# CITY OF ALBUQUERQUE

February 25, 2026

**RE: 1510 John St  
Grading and Drainage Plan  
Engineer's Stamp Date: 12/29/25  
Hydrology File: L14D071  
Case # HYDR-2025-00460**

ENGINEER'S SEAL	<b>LOT C LANDS OF SANDOVAL</b> <b>4220 ROMA DORA LANE</b> <b>GRADING AND DRAINAGE PLAN</b>	DRAWN BY RGE
		DATE 06/14/2022
2/10/26		4220 ROMA DORA DWG
DAVID SOULE P.E. #14522	ALBUQUERQUE, NM 87199 (505) 321-8099	SHEET # C1
		JOB #

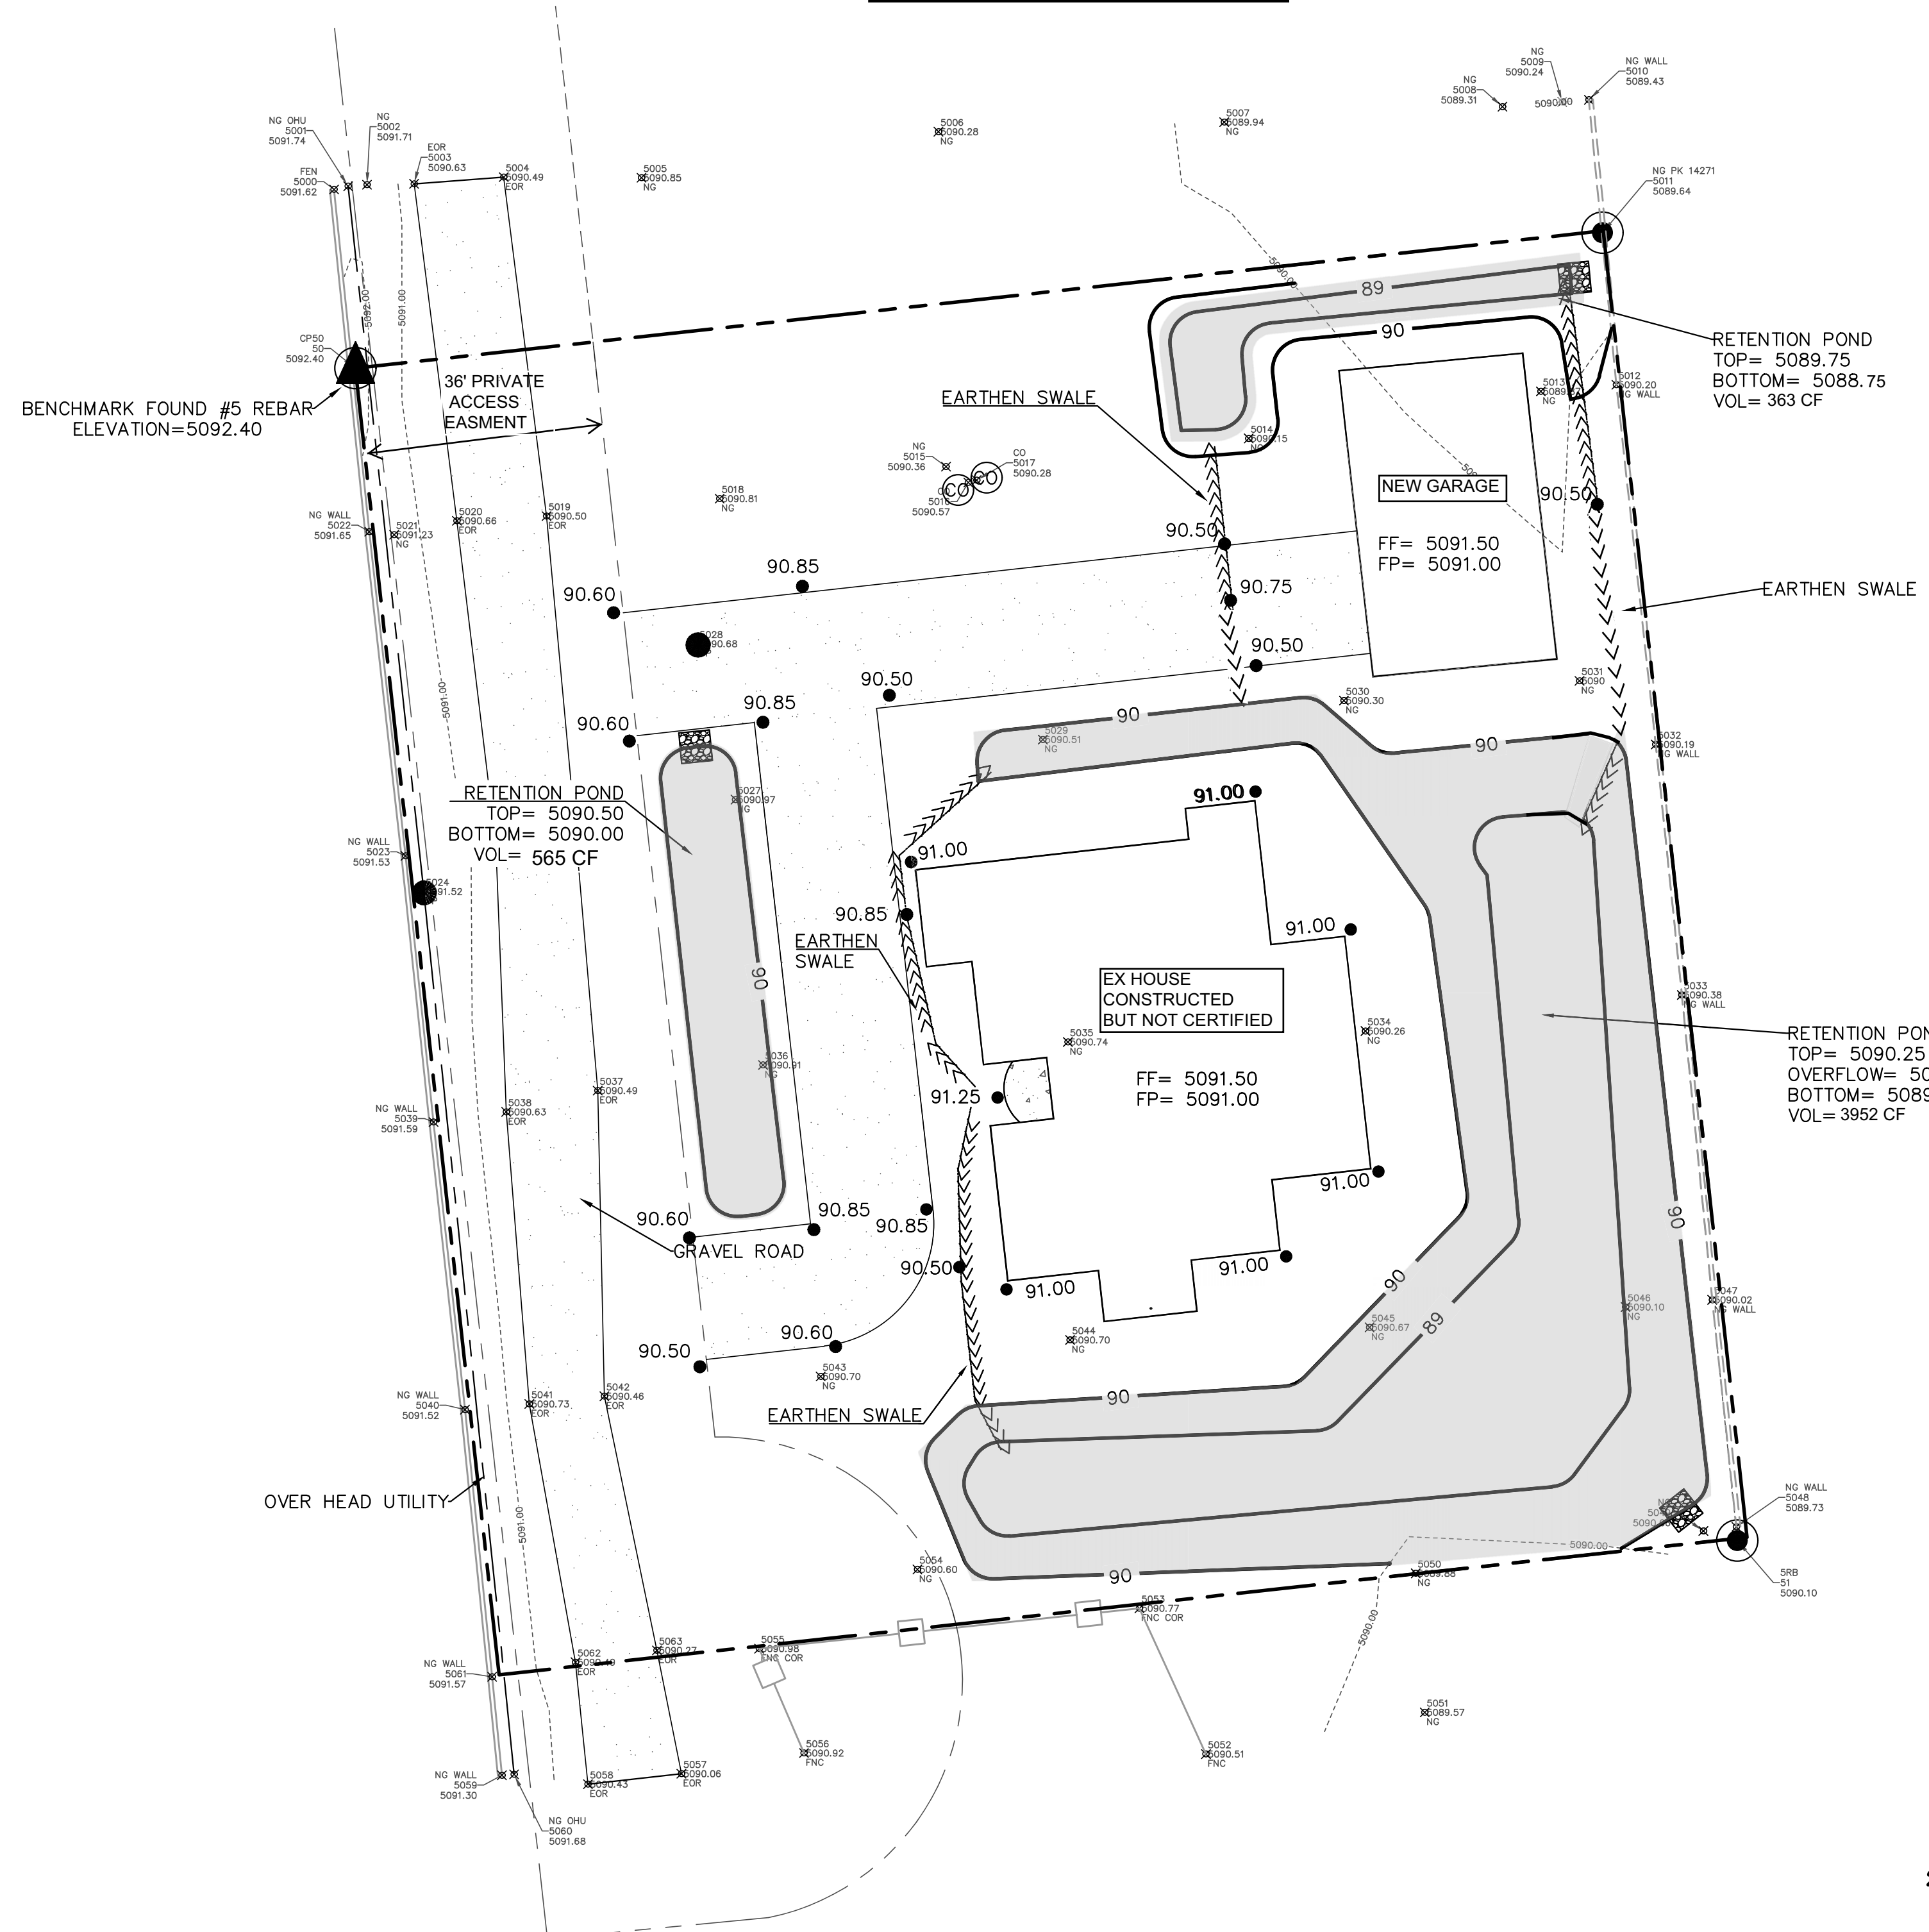
Based upon the information provided in your submittal received 02/20/2026, the Grading and Drainage Plan is approved for Grading Permit and Building Permit. Please attach a copy of this approved plan in the construction sets for Building Permit processing along with a copy of this letter.

1. Engineer's Certification, per the DPM Part 6-14 (F): Engineer's Certification Checklist for Non-Subdivision is required.
